Louisiana Coastal Protection and Restoration

Fish and Wildlife Service Planning Aid Report

Plan Formulation Planning Aid Report

**Provided to
New Orleans District/Vicksburg District
U.S. Army Corps of Engineers**

Figure 4. Recommended Barataria Basin levee alignment and wetland restoration features

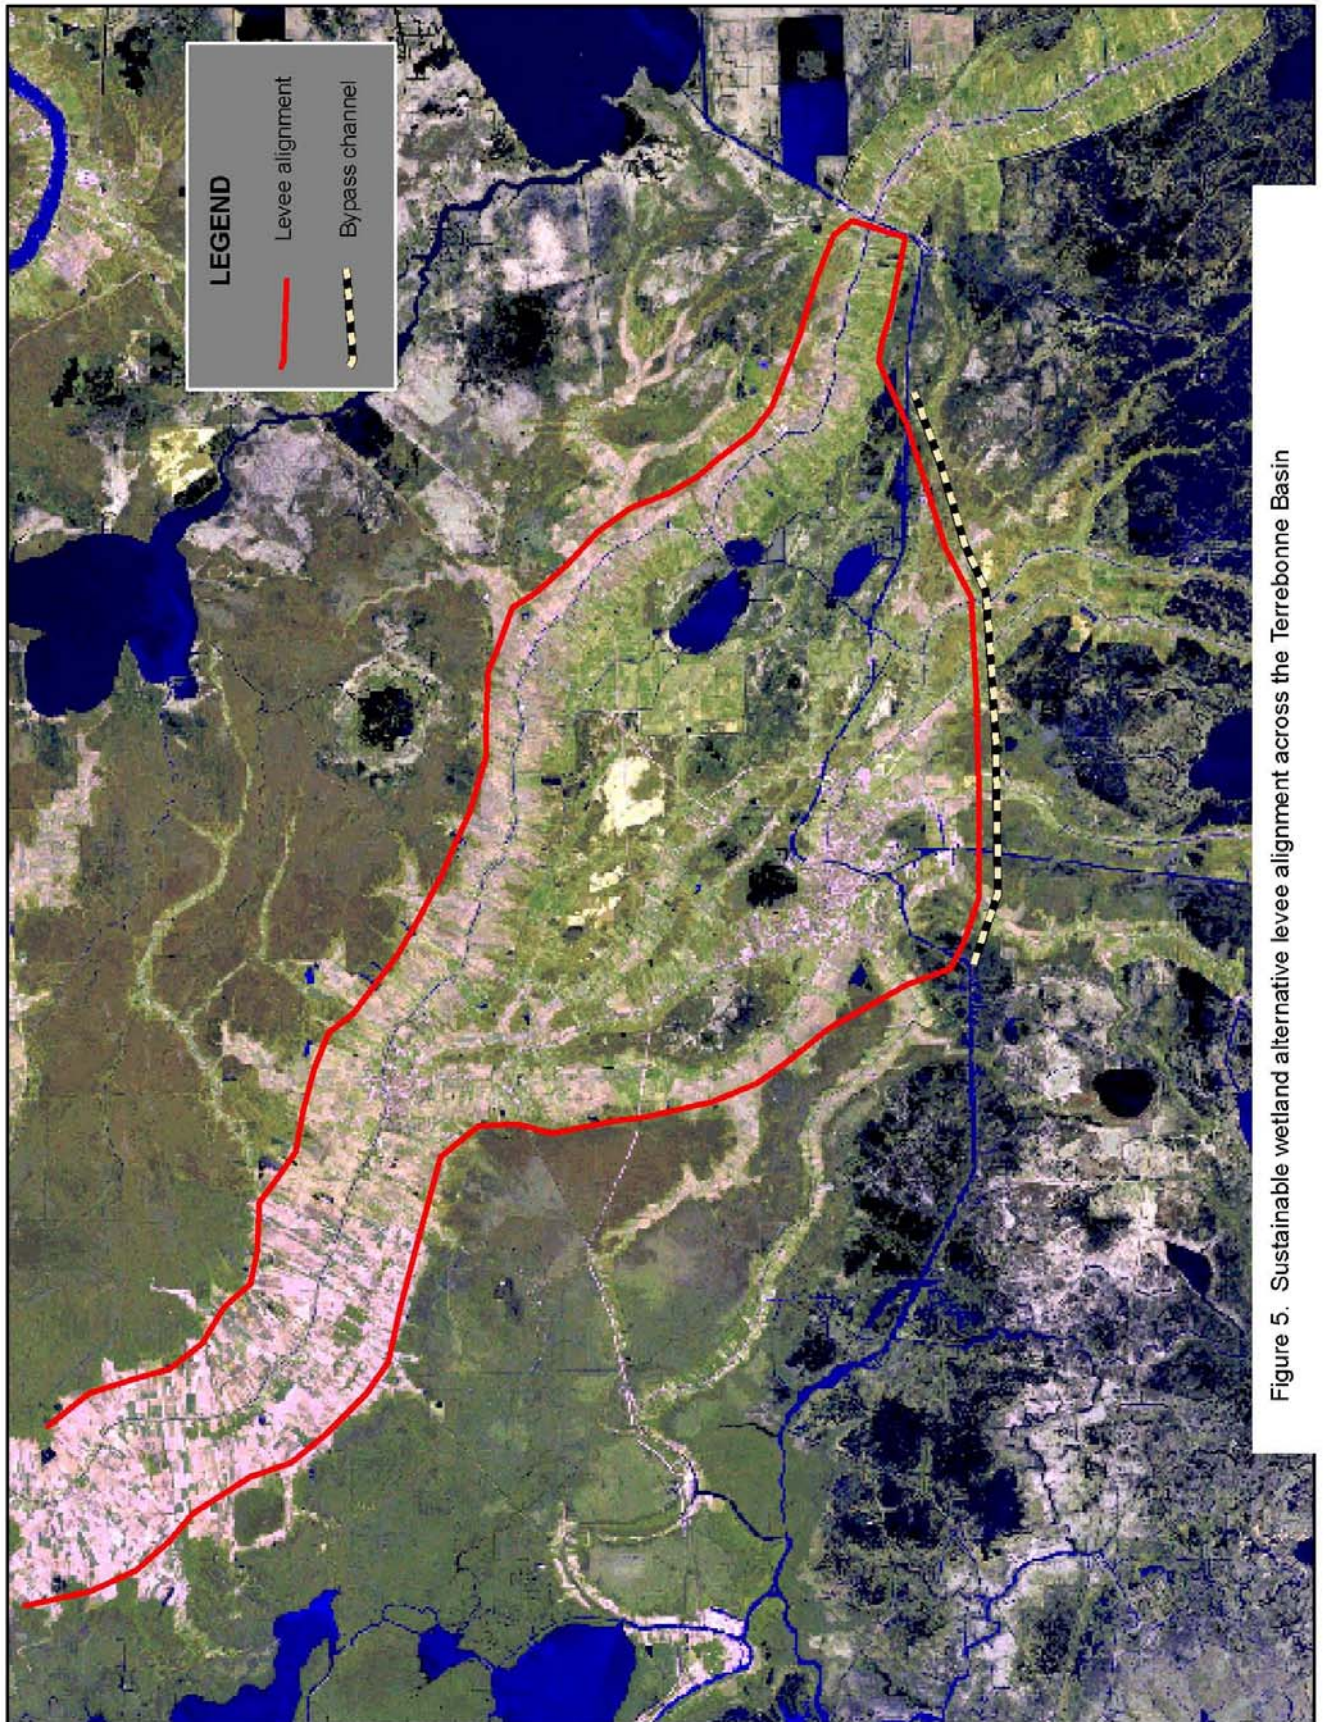
Some of the highest wetland loss rates in coastal Louisiana occur within the lower and middle Barataria Basin. Without sustainable wetland restoration, hurricane protection measures will be severely compromised in their ability to protect populated areas from storm surge to any degree of sustainability. The restoration of self-sustaining wetlands and other natural features would compliment hurricane protection features by providing outer lines of defense, and would potentially reduce long-term operation and maintenance costs of protection features. Wetland restoration features for the Barataria Basin should therefore focus on multiple lines of sustainable natural defense. Those restoration features should include barrier island/headland restoration, rebuilding of natural ridges, marsh creation/nourishment along bay shorelines and in other strategic locations, shoreline protection in critical areas, and river re-introductions to build wetlands and maintain existing marshes and swamps (Figure 4).

Wetlands flanking the lower Barataria Basin have deteriorated considerably such that future hurricane protection measures in those areas will be seriously compromised if restoration features are not implemented to provide natural protection as a first line of defense. Barrier island restoration, river re-introductions, natural ridge restoration, and marsh creation should form the basis of ecosystem restoration within the lower basin. Barrier island restoration would improve suspended sediment retention/deposition associated with proposed river diversion features, thereby improving the land-building efficiency of those features.

1. Create and maintain beaches, dunes, and marshes along the Caminada headland. Specifically, features being evaluated under the LCA Barrier Shoreline Feasibility Study should be implemented. (I)

5. Construct a sediment diversion (e.g., 15,000 to 20,000 cfs) near Myrtle Grove to rebuild marsh and nourish existing marsh between the Mississippi River and Barataria Bay. The area south of Myrtle Grove down to Round Lake and Lake Laurier has deteriorated significantly and very little wetland buffer remains to protect existing and proposed hurricane protection features in this area. The diversion should be sized to move significant amounts of sediment into this region to rebuild eroded wetlands and maintain existing marshes. (S)

Figure 5. Sustainable wetland alternative levee alignment across the Terrebonne Basin

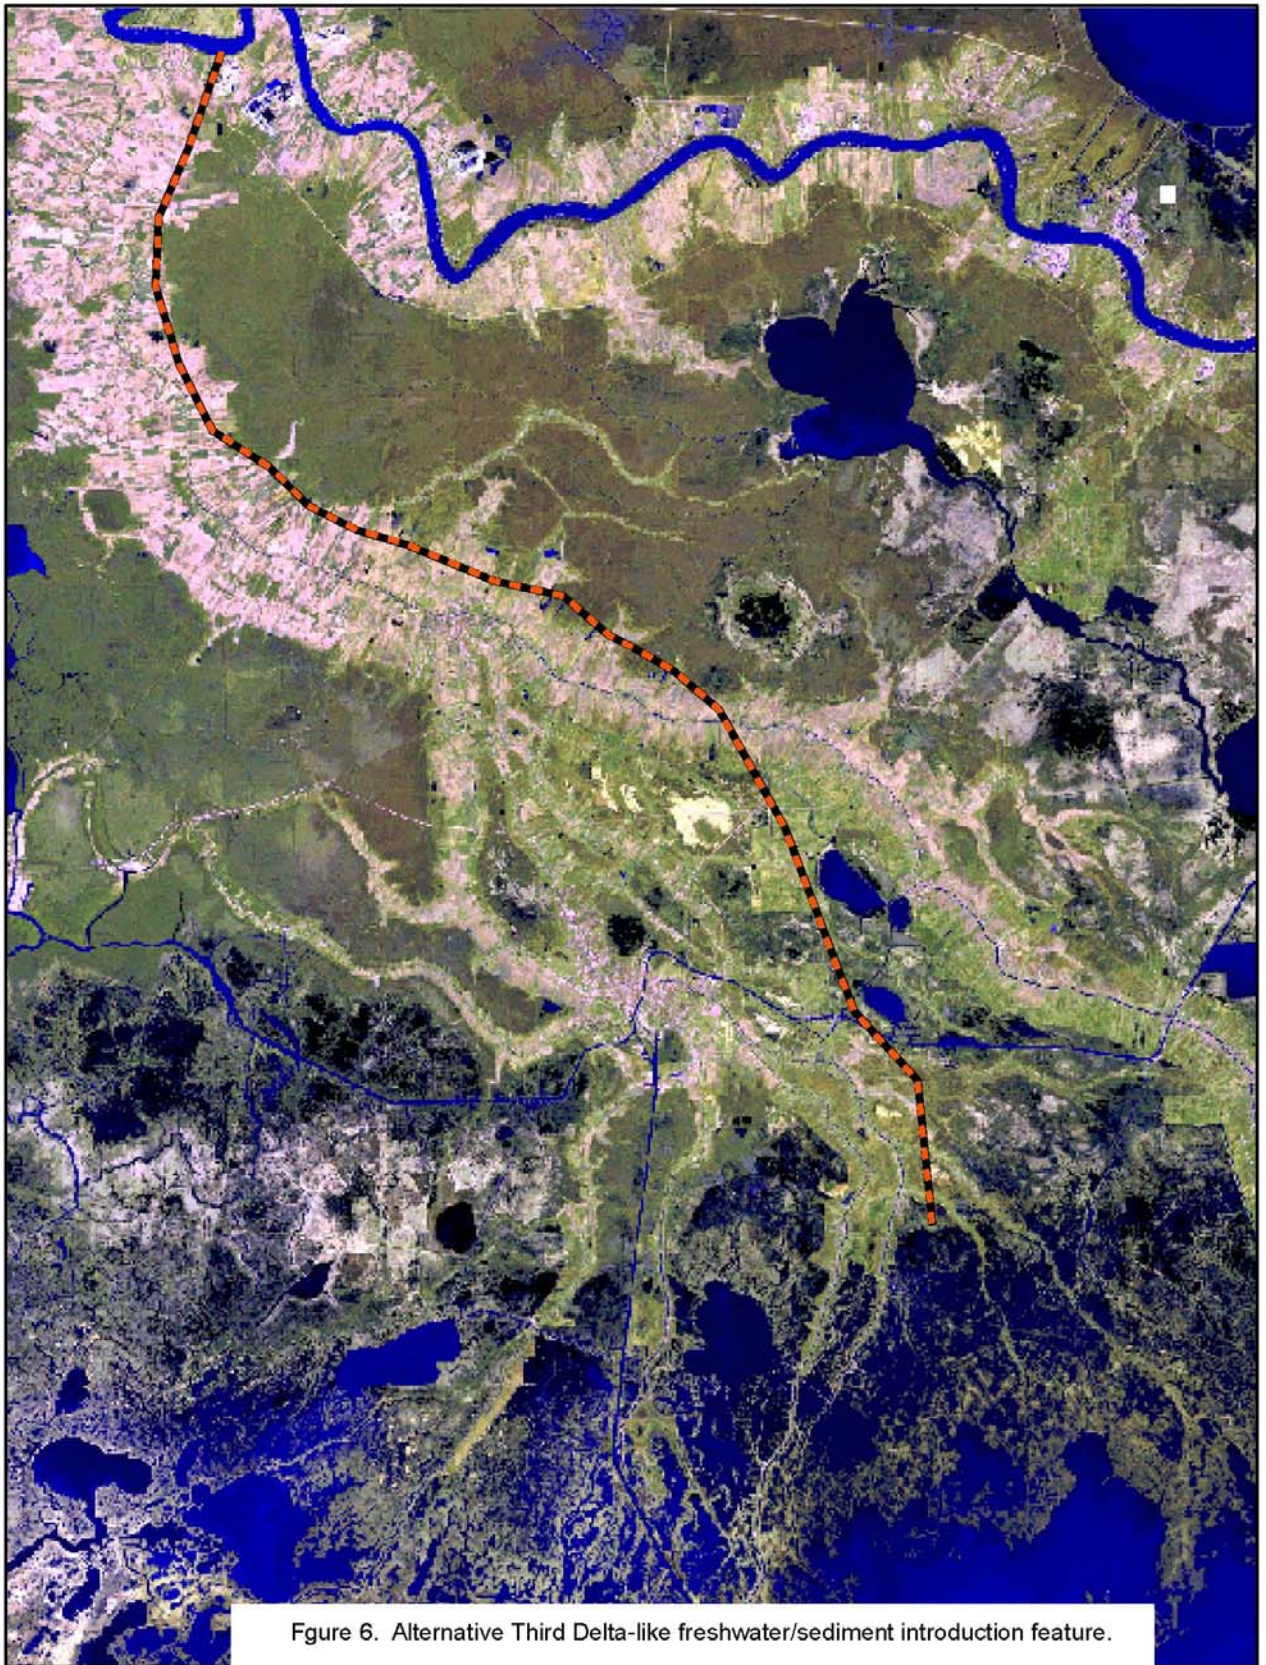
If the LSU alternative were constructed by creating a continuous borrow canal that would connect with the GIWW on either end (i.e., like a Houma bypass channel), and if it is appropriately sized and smaller distribution channels are enlarged, that borrow channel would create a very efficient and effective means of increasing Atchafalaya River freshwater flows to

portions of central and eastern Terrebonne Basin (Figure 5). On the other hand, the Houma Navigation Canal (HNC) Lock complex of the proposed Morganza alternative could stop northward saltwater intrusion up the HNC, and might if appropriately designed and operated, improve distribution of Atchafalaya River freshwater to wetland areas east and west of the HNC.

To achieve sustainability of Verret swamps and avoid enclosure-related fish and wildlife impacts of the Barrier Plan, the LSU alternative should be modified to extend the protection levee northward up the west flank of the Little Bayou Black ridge. Such an alternative would avoid enclosure-related wetland impacts within the Verret Subbasin and would facilitate construction of one or more diversions of Atchafalaya River water and sediment into the Verret Subbasin. Such actions would require that interior communities be protected from flooding by constructing ring levees, elevating structures, relocations, and/or buy-outs. Consistent with previous recommendations, associated levees should be constructed on non-wetlands for long-term sustainability, lower maintenance costs, and reduced wetland impacts.

Figure 6. Alternative Third Delta-like freshwater/sediment introduction feature.

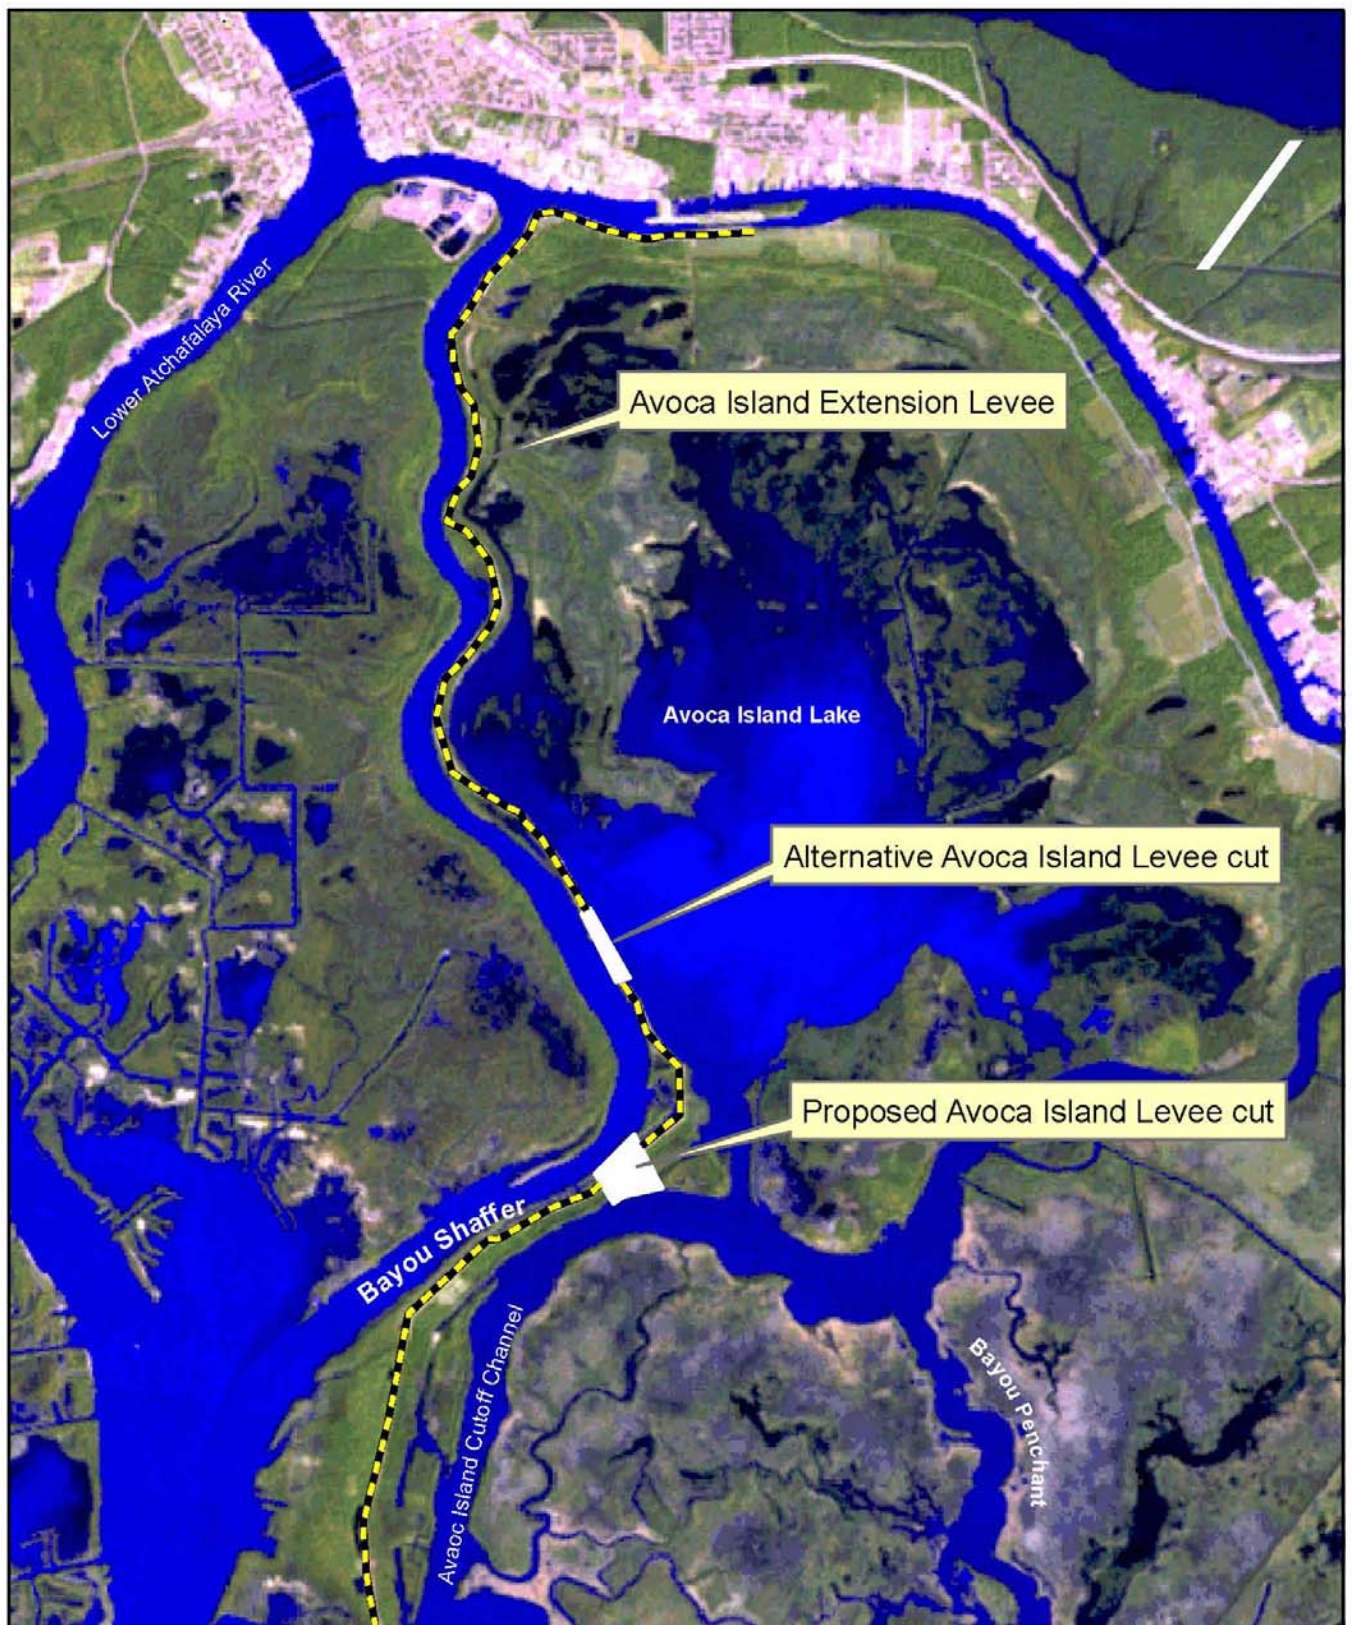
Central and eastern Terrebonne Basin marshes will be the most difficult area in which to achieve wetland sustainability because of their high loss rates, advanced stage of deterioration, and isolation from potential riverine inputs. However, construction of a modified Third Delta-like diversion feature into the Wonder Lake area would likely achieve and exceed that goal by maintaining the existing marsh and creating a substantial acreage of new marsh over the long-term (Figure 6). The Third Delta-like feature would also facilitate freshwater and sediment introductions into the upper Barataria Basin swamps and its construction could also create needed protection levees within a portion of that basin.

To provide more immediate hurricane protection and enhance the effectiveness of the modified Third Delta-like feature, the creation of an outer protective band of marsh would also be required. The Third Delta-like project feature would require maintenance, but by using natural energies and processes to achieve its goals, its benefited area would be relatively self-sustaining. If the GIWW could be used to distribute introduced freshwater to adjoining subbasins, then the sustainability of those adjoining areas would also be improved. Without a project feature of this type, a larger portion of central and eastern Terrebonne marshes would likely not be self-sustaining, and greater volumes of mechanical sediment addition to compensate for the long-term effects of subsidence would be required. Failing that, area communities will likely face the increasing risk of repeated storm-related damage and substantial costs for maintaining protection levees.

1. Construct a modified Third Delta-like diversion into Wonder Lake. Construction of this feature would eliminate or reduce the need for the recommendation 2. (S)
